Bulletin No. 2002-06

Discharged Battery Following Periods of Extended Non-Use - 75/90 (4-Stroke)

MERCURY/MARINER
 2002 Model Year
 75/90 (4-Stroke)
 S/N OT416815 thru OT445963
 S/N OT448964 thru OT514337
 S/N OT515038 thru OT552004

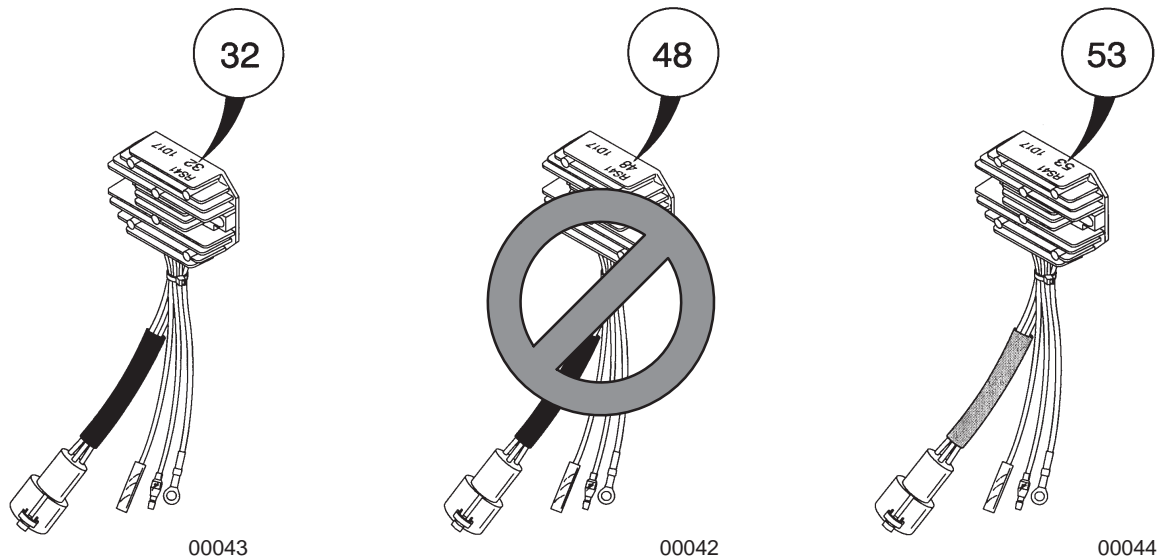
Inspect the voltage regulator/rectifier of affected units during pre-delivery inspection or any time an affected outboard is brought in for other service/maintenance work. The chart below identifies when the voltage regulator should be replaced.

Part Number	Sleeve Color	Printed I.D.	Comment
804278T	Black	32	Do Not Replace
804278T 1	Black	48	Replace
804278T11	Gray	53	Do Not Replace

Replace voltage regulator/rectifier assemblies that have an I.D. stamp "48" with a black sleeve around the 3-pin wiring harness, as shown in the above chart.
